Subject: North Yarmouth Booster Pump Station
Yarmouth Water District Addendum to Site Plan Review

Addendum to Application for Site Plan Review

North Yarmouth Booster Pump Station

YARMOUTH WATER DISTRICT
NORTH YARMOUTH BOOSTER STATION
ADDENDUM TO APPLICATION FOR SITE PLAN REVIEW

Attachment B
Amended Light Fixture Cutsheet

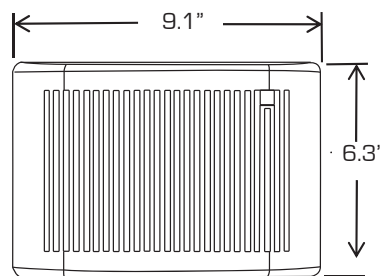
This Section was not raised as a concern; however, changes to the exterior lighting have been proposed to make the lighting more pleasing to the eye. A cutsheet of the proposed fixtures is included in Attachment B. This is an LED downward facing fixture with a “slim” design.
